Title			
Pixel Mezz-2			
Size	Document Number	Rev	
B	<Doc>	<RevCode>	
Date:	Monday, November 17, 2003	Sheet	1 of 1

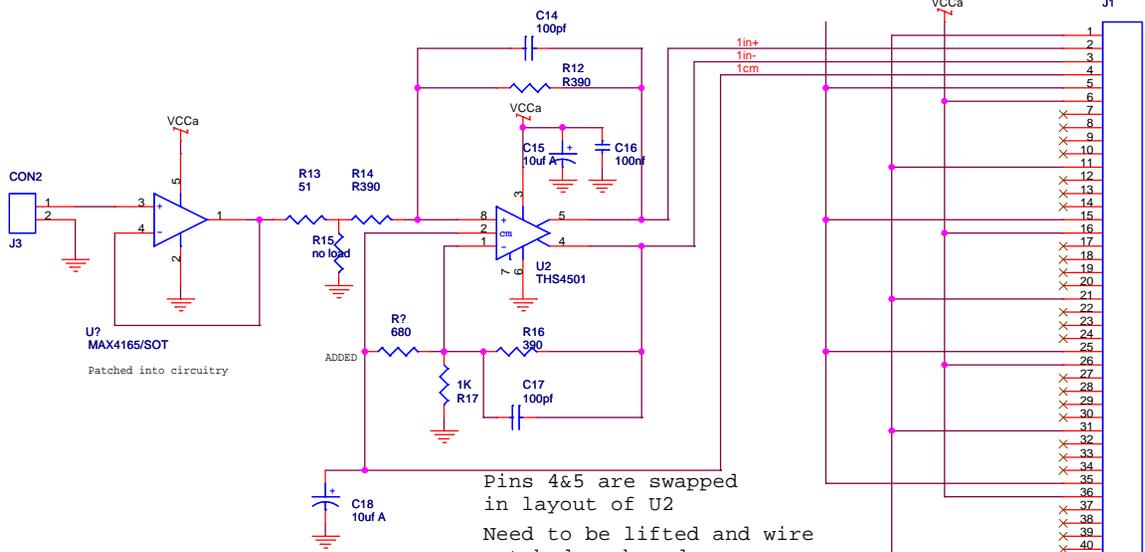
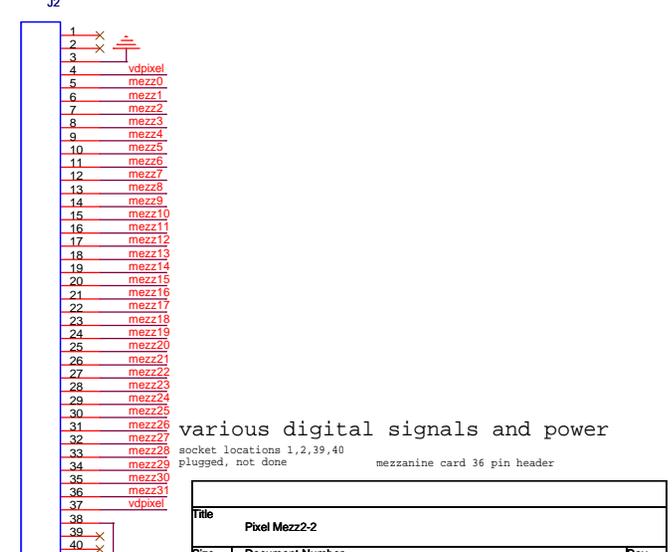
Pins 4&5 are swapped in layout of U2  
 Need to be lifted and wire patched on board  
 This schematic is shown corrected
